SERVICE BULLETIN QUA/03/001

(QUASAR AMUSEMENT RIDE)

SEPTEMBER 1988

SERVICE BULLETIN QUA/03/002

MODIFIED CONSTRUCTION (CRANK TYPE)

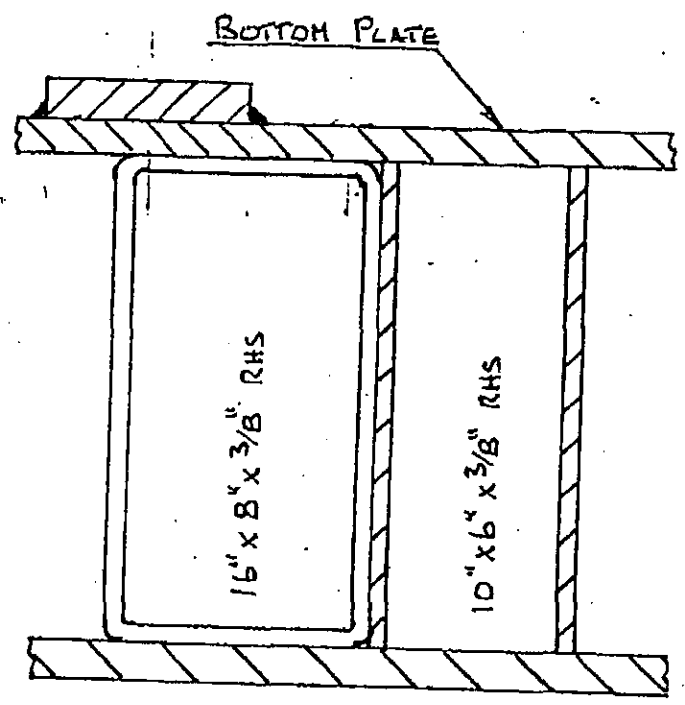
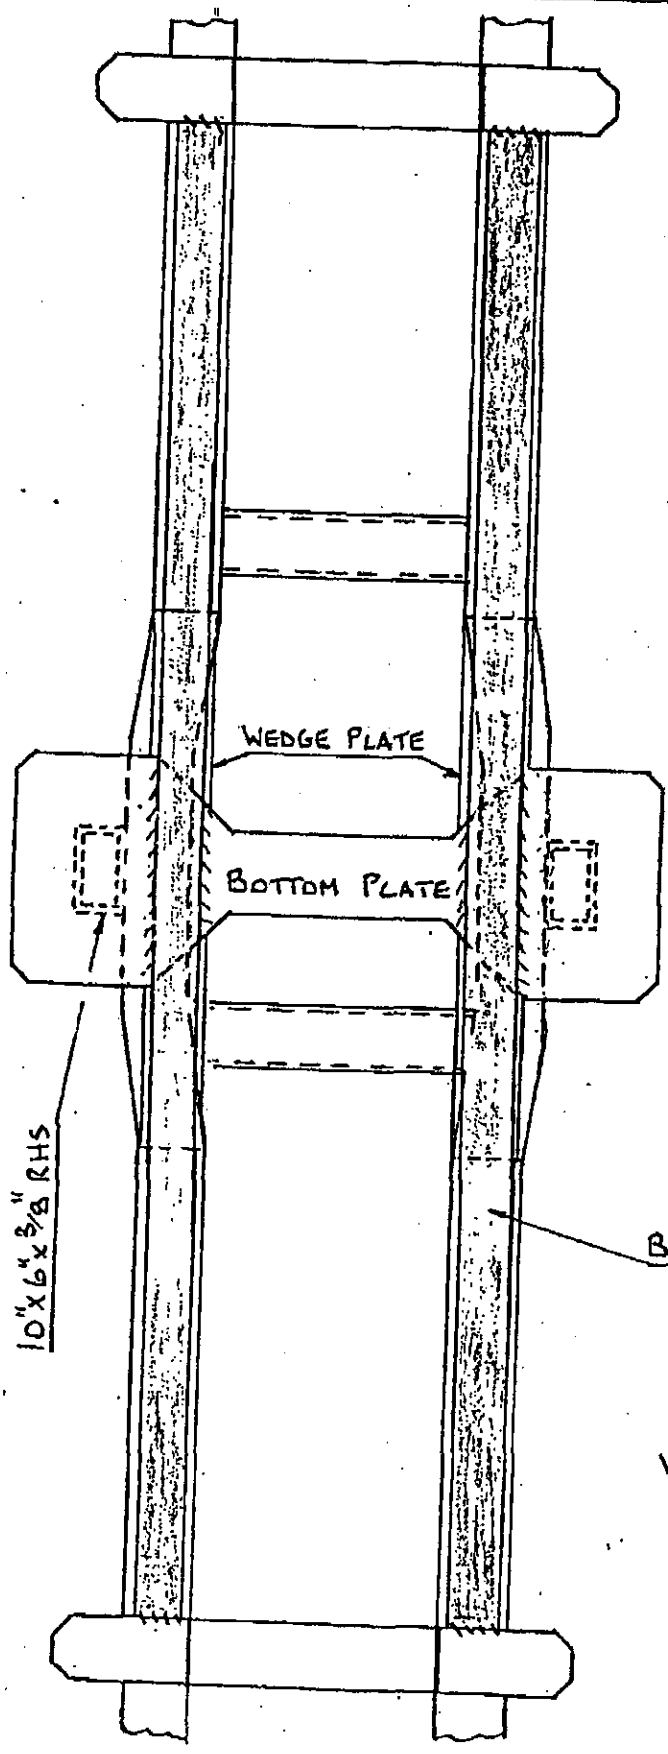
2. Weld wedge plates to underside of main members butting angled end up to bottom plate and welding together.
3. Position bracing strap over bottom plate. Weld strap to bottom plate and bend down to follow contour of wedge plates. Weld strap to wedge plates and main members. See Pages 7 and 8.

QUASAR SUB-FRAME

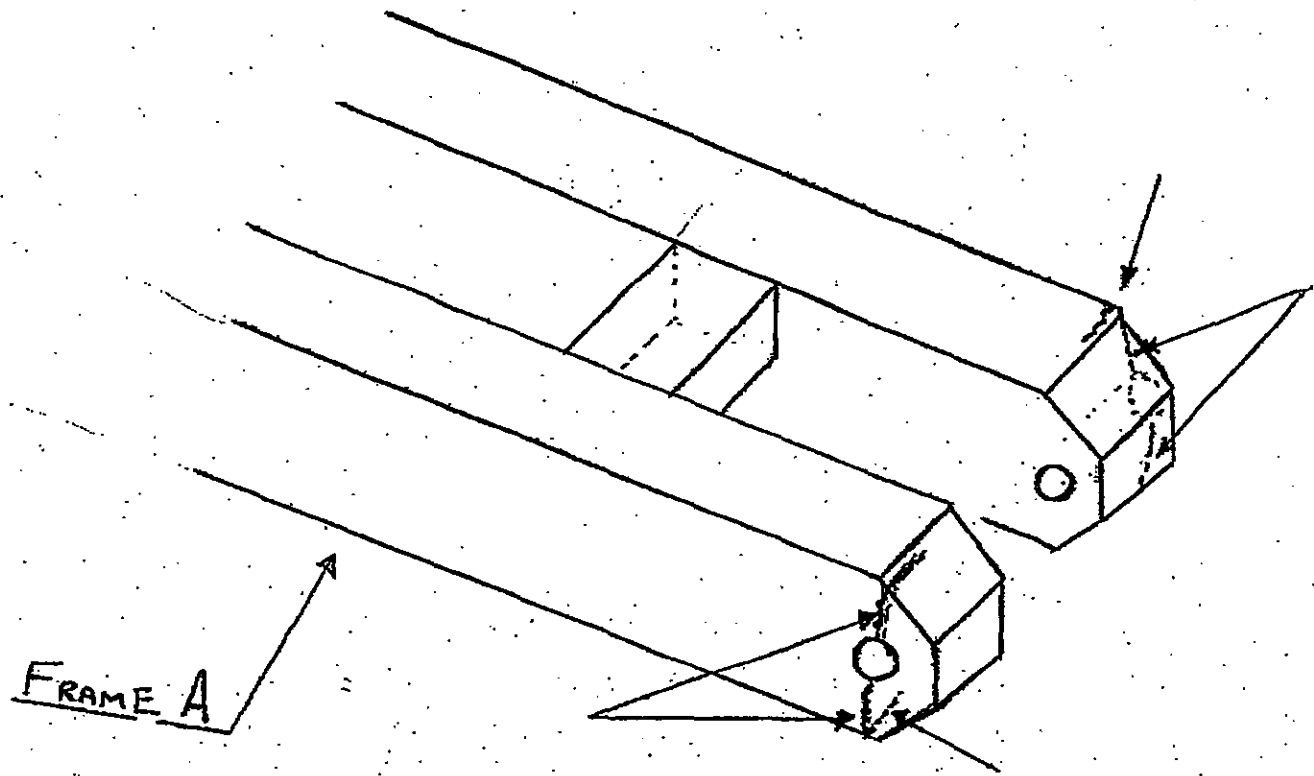
It has been noted that one Quasar has developed cracks on the 'H' frame upper pivot points, radiating from the hinge pin holes (see attached sketch).

CRACKS FOUND ON 'H' FRAME AT THIS POINT

CRACKS RADIATING FROM HINGE PIN HOLES BOTH SIDES.
AND RUNNING ACROSS BOX SECTION

All operators must inspect for cracks in this area. If any cracks are found, please inform the manufacturer and ensure that the ride is not used until repairs have been carried out.

SIDE ELEVATION ON LIFTING FRAME

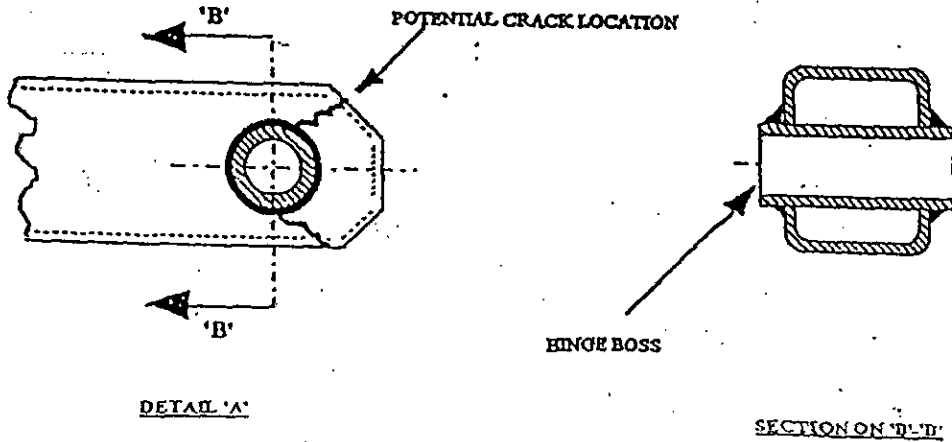
On investigation it would appear that some hinge bosses may have inadequate weld preparation and may suffer fatigue induced cracking emanating from the area of the hinge boss and propagating outward at 45° into the parent metal of the links.

- 1) Visual inspection of the area immediately in the vicinity of the hinge bosses situated at either of the two main travelling links, one link being ram driven and one being a trailing link

Check for any indication of a crack both in the weldment of the boss to the link and also in the link parent metal. If cracks are visible then these areas are to be subjected to non destructive testing as in 2) and 3) below to determine the extent of any possible damage.
